We revised manuscript AMT-2022-288 and its supplement in accordance with the comments by two anonymous referees. The comments and replies are listed below and correspond to those submitted in the open discussion. Marked-up versions of the manuscript and supplement were uploaded as well, however in a separate file as requested by the upload page. As requested, we changed to a one-column format for the supplement.

Reply to Anonymous Referee #1

Referee comment on "Optical receiver characterisations and corrections for ground-based and airborne measurements of spectral actinic flux densities" by Birger Bohn and Insa Lohse, Atmos. Meas. Tech. Discuss., <https://doi.org/10.5194/amt-2022-288-RC1>, 2022

New figure X: "Top and bottom receiver positions of the three HALO configurations FLT, FLN and FLV. Adapted from a figure used with permission by DLR, Germany."

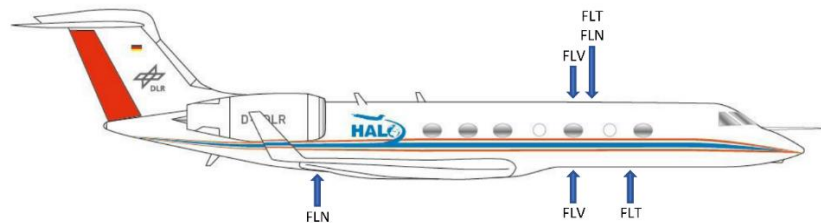
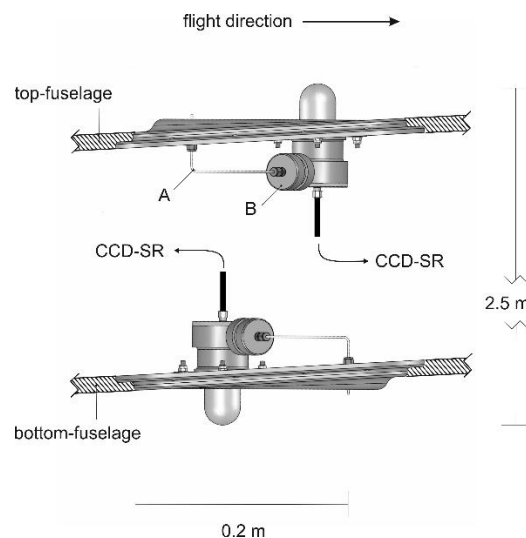
Lines 114-5: I do not see a description of FLT, FLV and FLN. Nor do I understand the acronyms. Figure S7 does give some information but does not distinguish between FLT and FLN.

Reply: The acronyms were originally chosen to distinguish between ground and airborne configurations: GRD for "ground" and FLT for "flight". In a subsequent deployment the "nadir" receiver position was changed, and this configuration was named FLN. In another campaign both receivers were placed in the larger "viewport" adapters (Fig. S7) of HALO which led to the acronym FLV. We don't think the reader should be bothered with this acronym history. On the other hand, we noticed that the acronyms GRD and ZEPP_FLT were not mentioned in the manuscript but are used in some of the file names in the online material. We therefore added a sentence in the Supplement, page 14 line 27 to clarify: "The configurations can be inferred from the filenames: GRD refers to corrections for the four receivers on the ground, ZEPP_FLT to the Zeppelin configuration, and HALO_FLT, HALO_FLN and HALO_FLV refer to the three HALO configurations." Moreover, we added a new figure (see below) after Fig. 2 showing the receiver positions of the three HALO configurations and added one sentence in line 117: "The receiver positions of the three configurations are indicated by arrows in Fig. X."

Revised Fig. 11: "... Cloud layers are indicated by grey-shaded areas..."

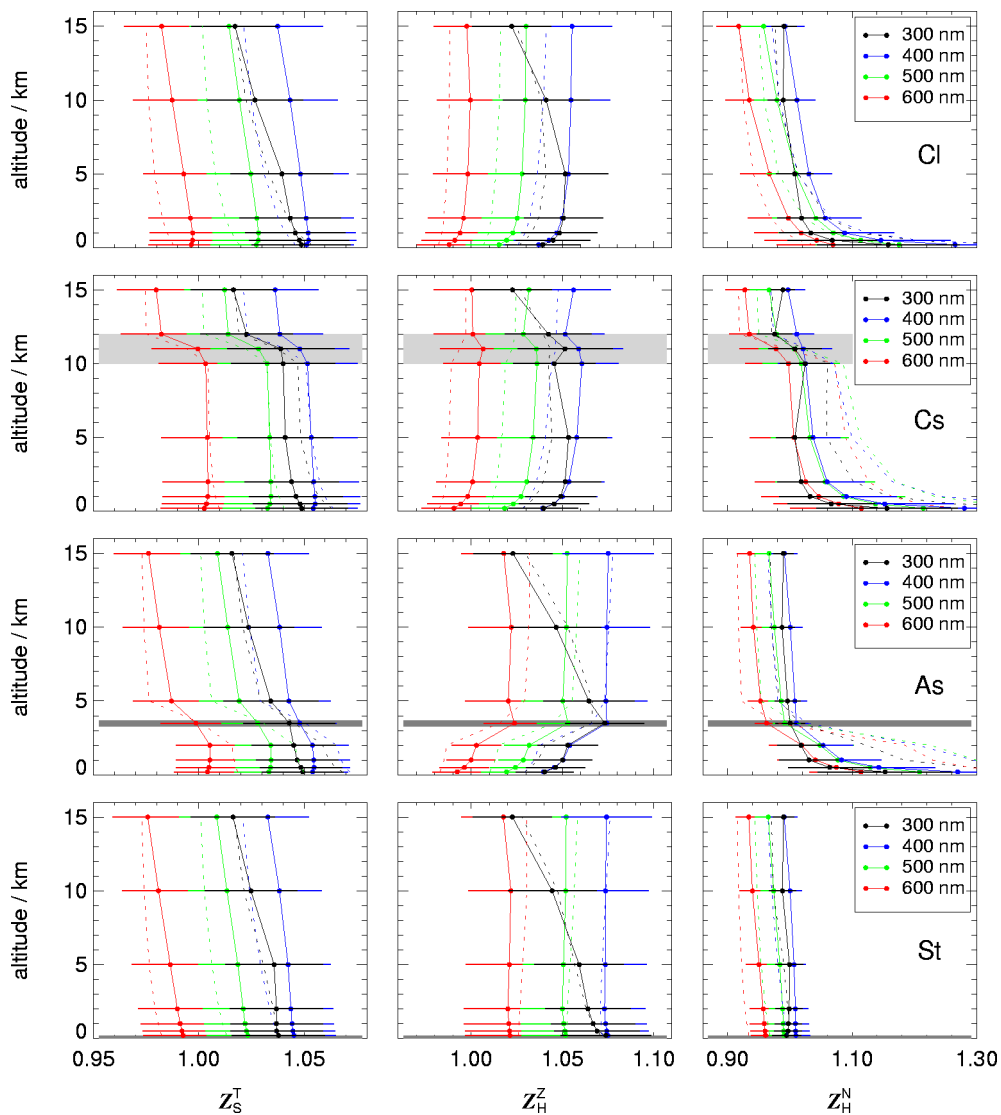
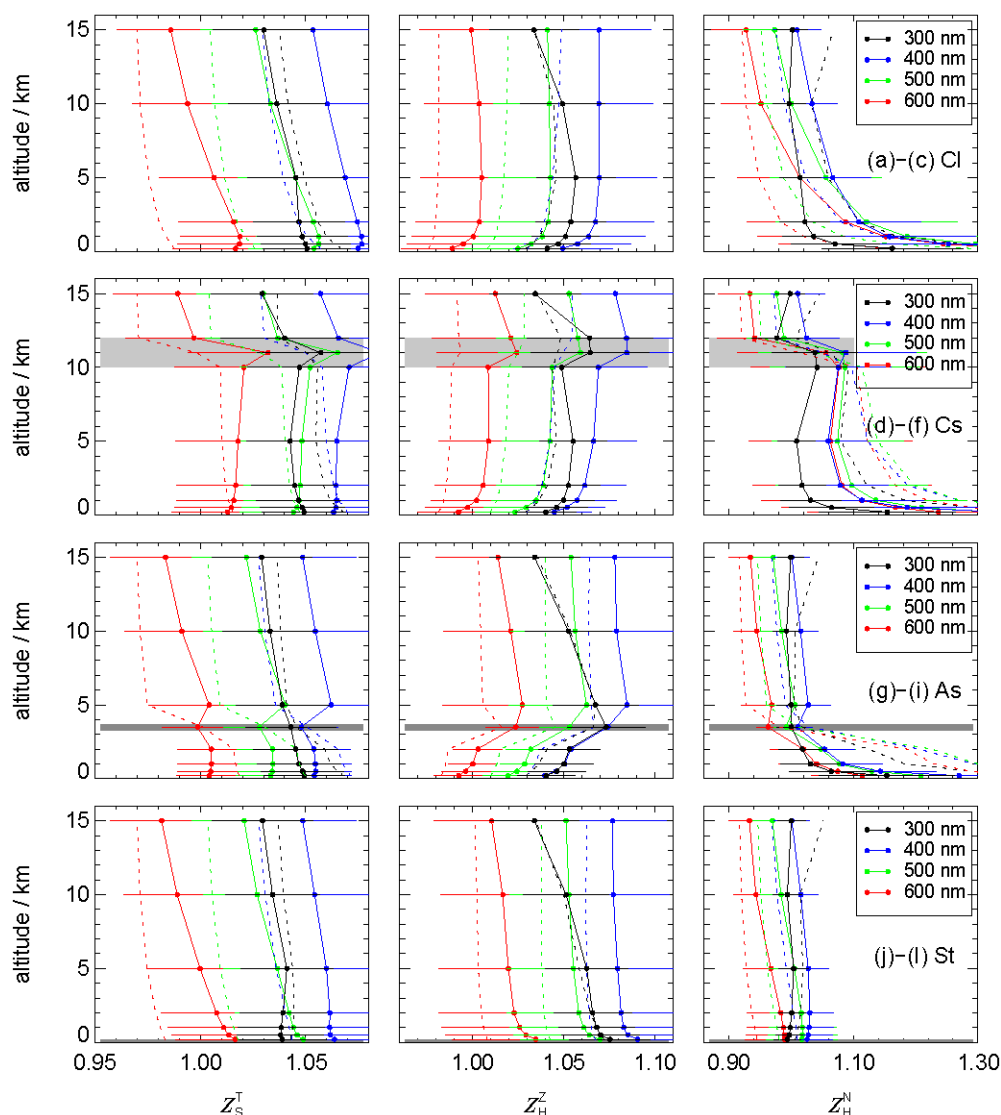
Figures 11 and S27: The grey bars for the Cs cloud in these figures are deceiving. The cloud ranges from 10-12 km but is shown as a thin line at 11 km. I also suggest adding a point at 12 km to show the correction from the bottom to the top of the cloud.

Reply: As suggested, we made additional simulations and derived corrections for the cirrus cloud case at 12 km. The figures were revised, and the cloud covers were included more realistically by grey areas indicating their depths (see revised Fig. 11 and Fig. S27 below). The 12 km corrections are close to those at 15 km and will not be used for the parameterizations (like the in-cloud corrections). In line 472 we added: "...at the intermediate altitudes of 3.5 km (As) and 11 km (Cs) as well as from above-cloud at 12 km (Cs) were not considered..." The 12 km data were included in version 2 of the online material.

Revised Fig. S27: "... Cloud layers are indicated by grey-shaded areas...."

Revised Fig. 15: ... The color-coded error bars correspond to total uncertainties including those from corrections and calibrations (Sect. S7, Supplement). The overlying grey error bars indicate the uncertainties from the corrections alone. ...

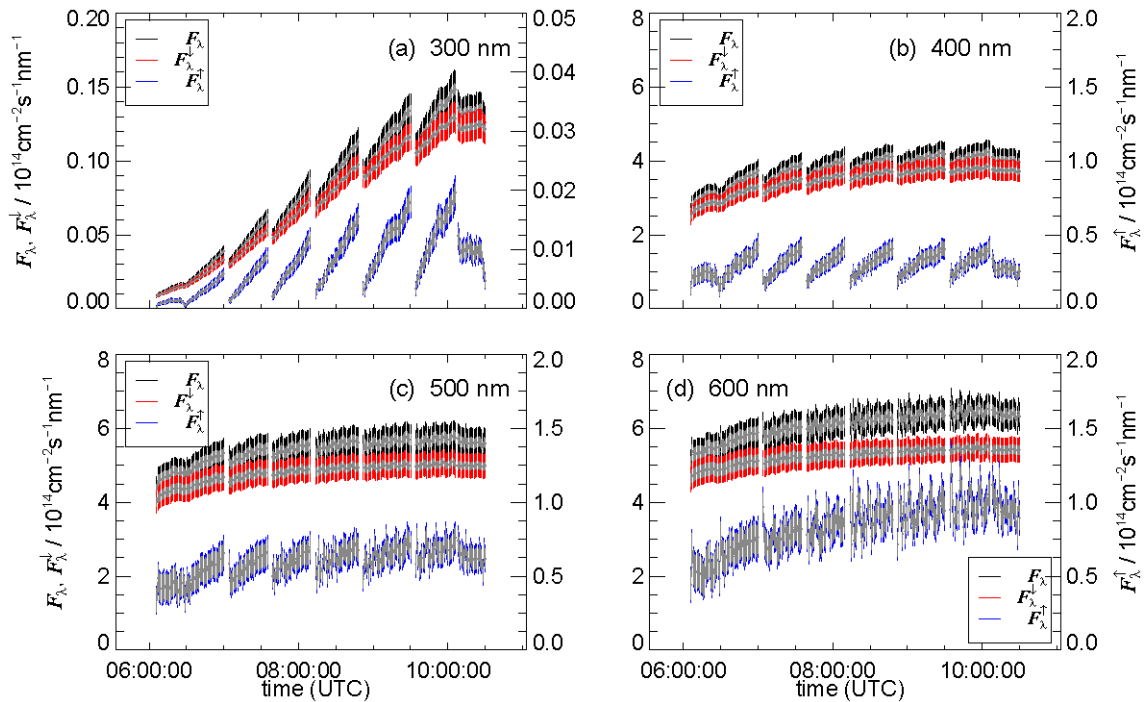
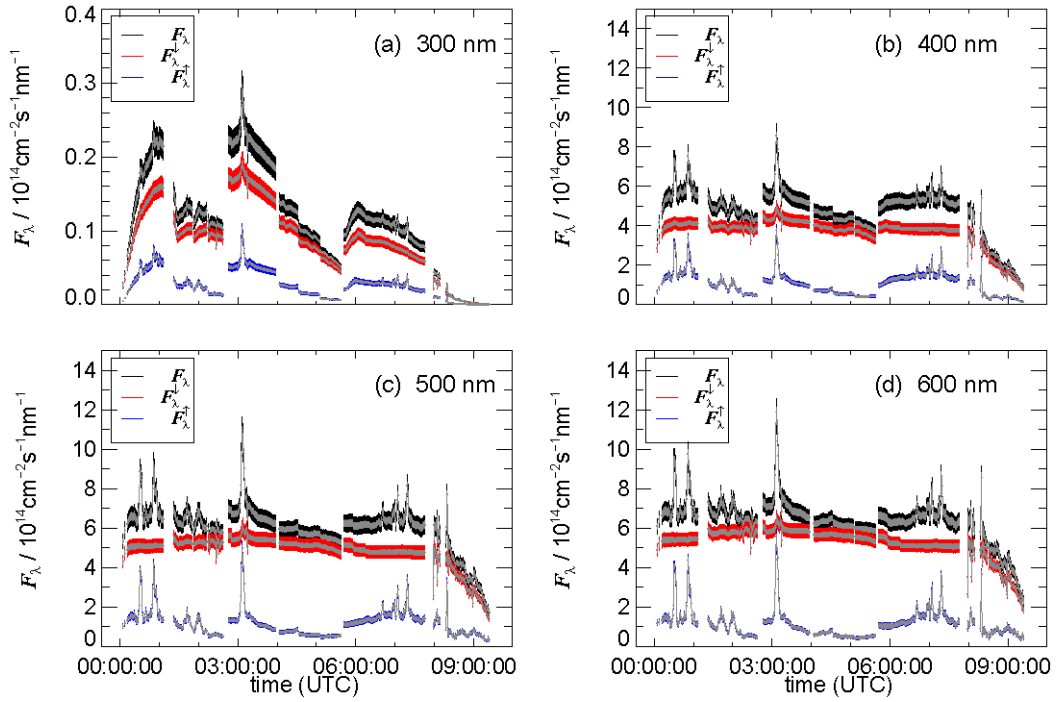
Figure 17: The error bars show the uncertainties from the corrections and calibrations. I was disappointed not to see the impact of the corrections alone as that is the point of the entire paper. It should be shown in this figure (or another) and well explained in the text. The fact that they may be relatively small (especially on this HALO flight) is important.

Reply: The uncertainties of the corrections are shown separately in Figs. 14 and 16 where they can be examined in greater detail. In Figs. 15 and 17 they are difficult to see for smaller values of the flux densities. Anyway, we now show both, total errors and those of the corrections alone as grey overlays. In the text we now write (line 502): "The finally derived total, downward and upward spectral actinic flux densities are shown in Fig. 15 together with their total uncertainties and those resulting from the corrections. The latter are dominant for the upward component and less significant for the total and downward." And in line 520 for HALO: "The finally derived spectral actinic flux densities and their uncertainties are shown in Fig. 17. The uncertainties from the corrections are again more significant for the F_{λ}^{\uparrow} especially at low altitudes. Flux densities ..."

Note that the date was removed from the x-axis ("time (UTC)" was added instead), the x-range was changed, y-ranges for 400, 500 and 600 nm are the same now and panels are labelled (a)-(d) in response to referee #2.

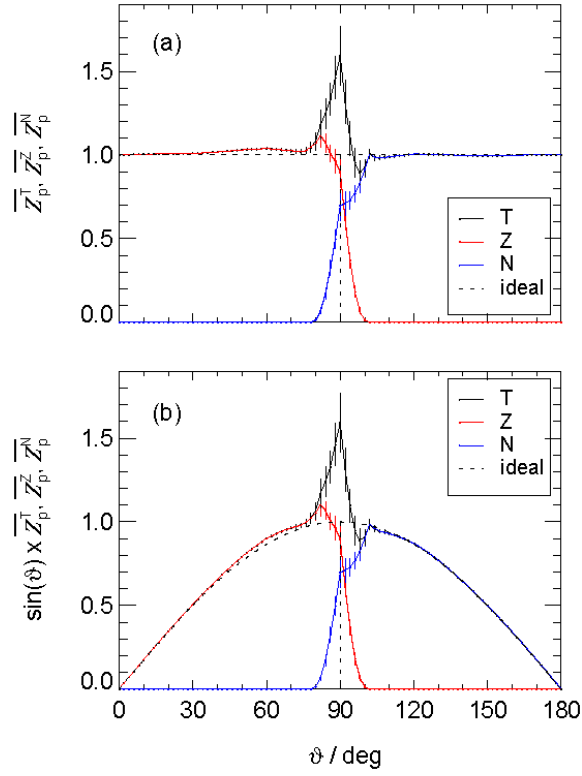
P8L172: "Because of the rotational symmetry of the receivers, dependencies on azimuth angles are minor." From the contour plot (Fig.3b), I would estimate a distinct variation of the angular sensitivity in azimuth direction (for 60° polar angle). Is this considered as minor dependence?

Reply: Each receiver is different. As the example shows, there were some variations in a 5% range. These can still be considered as minor because they do not translate to a 5% variability of the measurements unless radiation is received from a single direction. We changed from "minor" to "typically minor (<5%)" to specify.

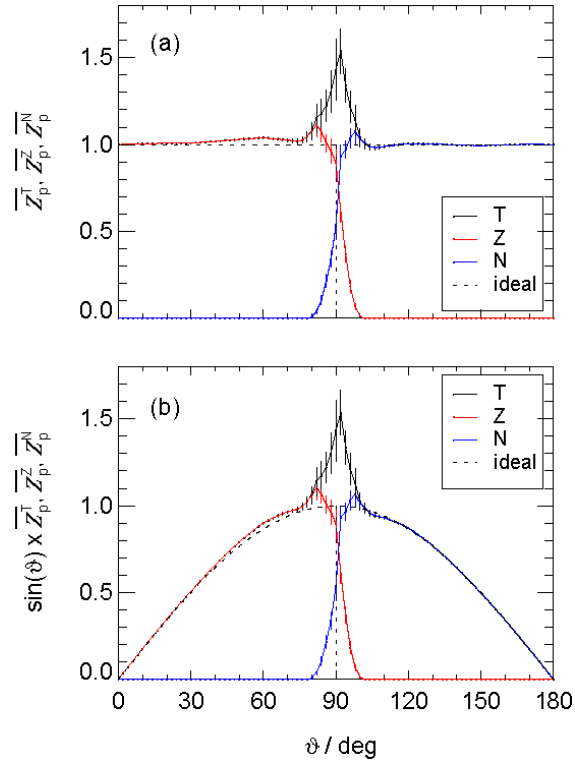
P11 Fig5: Here, azimuthal averages are plotted. Think about to show also the corresponding standard deviation as in Fig. 4.

Reply: The referee probably means Fig. 6. The standard deviations would be misleading here because the field-of-view effects can introduce strong azimuthal dependencies close to the horizon as shown in Fig. 3. Instead, we added the estimated uncertainties for the mean values and noted this in the caption of Fig. 4 and the corresponding Figs. S9, S11 and S13, see below. As mentioned in L195-199, Fig. 5 merely serves to visualize the (average) contributions of the top and bottom receivers. These mean data are not used to calculate corrections except for the hypothetical case of an isotropic radiance distribution as discussed in the paragraph L200-204. In this case the use of the mean values is justified. The final corrections are calculated based on the data shown in Fig. 5 (exemplarily for 400 nm). To clarify we extended the sentences in L204-206: "In order to obtain more realistic corrections, sensitivity distributions as shown in Fig. 5, as well as wavelength dependent direct sun contributions and diffuse spectral radiance distributions are required. The latter information is usually not available under measurement conditions."

Revised Fig. 6.: (a) Azimuthal averages of total relative angular sensitivities Z_p^T (T) of HALO shown in Fig. 5 with contributions Z_p^Z (Z) and Z_p^N (N) of top and bottom receivers, respectively, for a wavelength of 400 nm (2° -interpolations). Error bars represent estimated mean uncertainties not covering azimuthal variabilities. The sensitivities of ideal 2π and 4π -receivers are shown for comparison (dashed lines). (b) The same data as in (a) but multiplied with $\sin(\vartheta)$ to account for the ϑ -dependence of solid angle contributions.

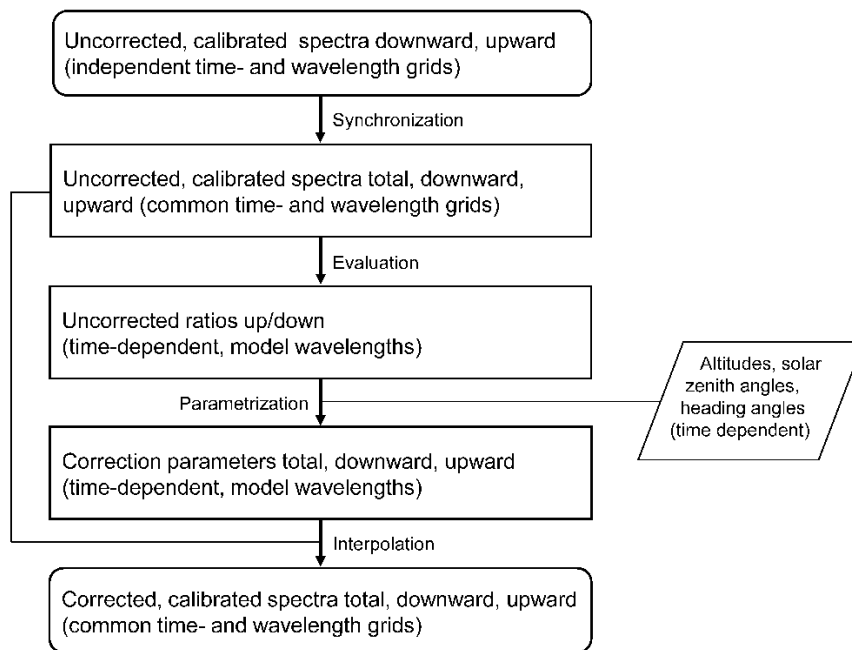
P25 Fig.12: The number of dots should be 3 x 5 x 3 for this scenario, but it looks like less.

Reply: The scenarios that were used for the analysis are listed in Tab. S1. However, the scenario groups T (3) and A (5) share one scenario (with standard ground albedo and aerosol) which was not explained. We therefore slightly revised the table caption: "The letter T (turbidity) denotes three scenarios with different aerosol optical depth cases at standard ground albedo ($A_{470} = 0.04$), the letter A (albedo) four additional scenarios with different ground albedo cases at standard aerosol optical depth ($AOD_{550} = 0.2$)."

The total number of scenarios therefore is $(3+4) \times 3 = 21$ for the Zeppelin in Fig. 12 and $(3+4) \times 3 + 3$ (Str) = 24 for HALO in Fig. 13.

Revised Fig. 14.

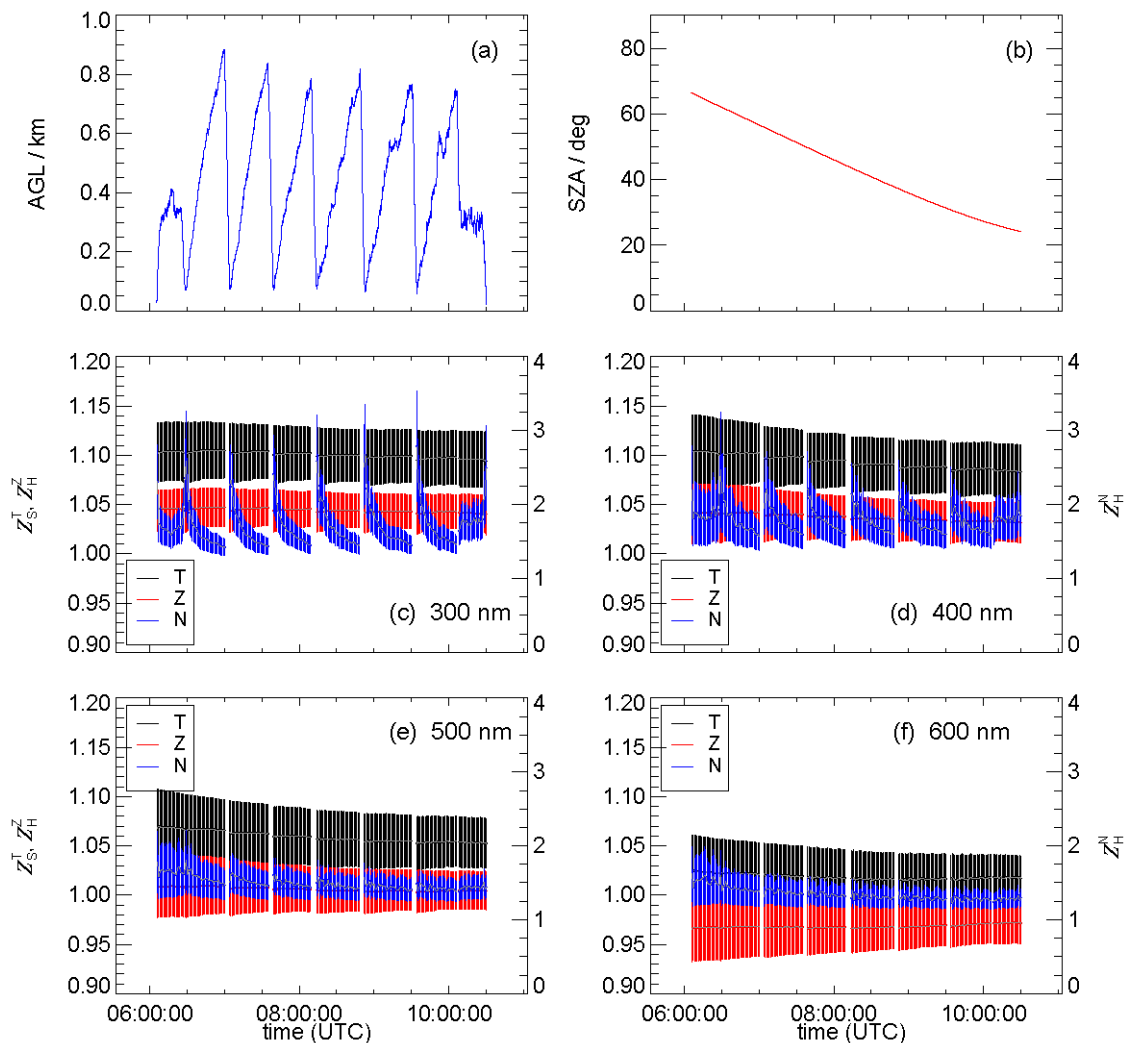
P28 Fig.14: Maybe adjust the range of the x-axis (zoom in, e.g. 06:00 – 10:15 UTC). The date is not required as x-axis label.

Reply: We changed the range of the x-axis, removed the date from the label and replaced it by "time (UTC)" to create a proper label, and rearranged the legends and labelling. Fig. 16 (HALO) was changed accordingly.

Revised Fig. 15. Error bars from the corrections alone are shown in addition, in response to referee #1.

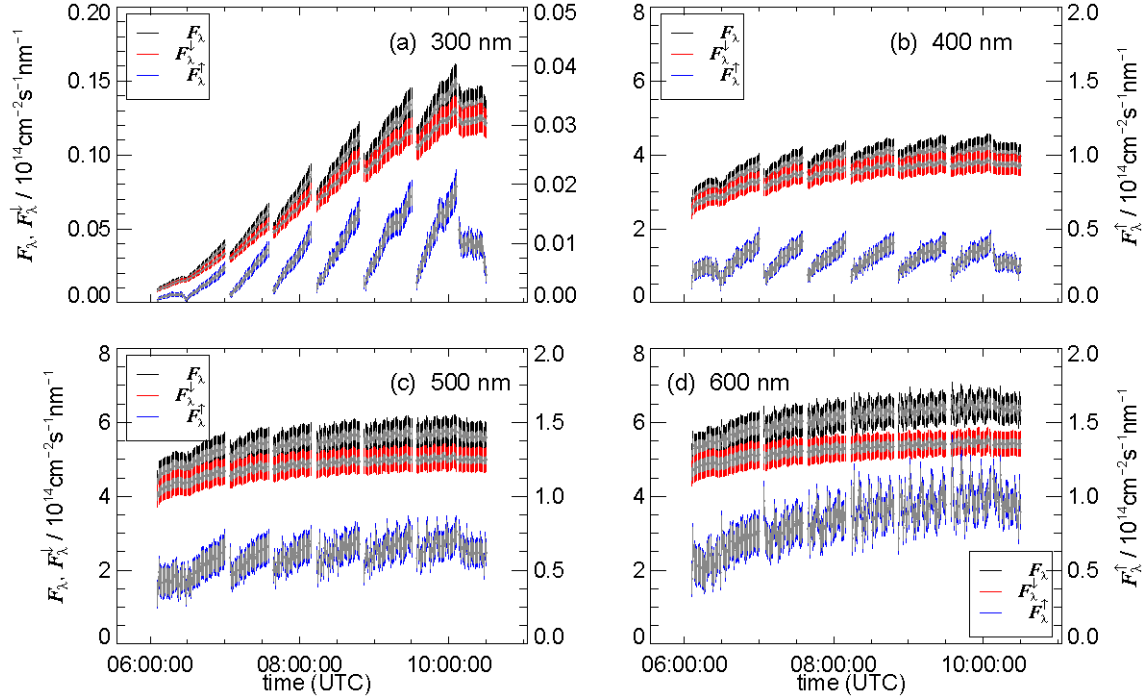
P29 Fig. 15: Use the same y-scale if appropriate. It helps to make the plots more comparable.

Reply: The y-range of the three VIS-range panels are the same now. Labelling was made as in Fig. 14. Fig. 17 was changed accordingly.
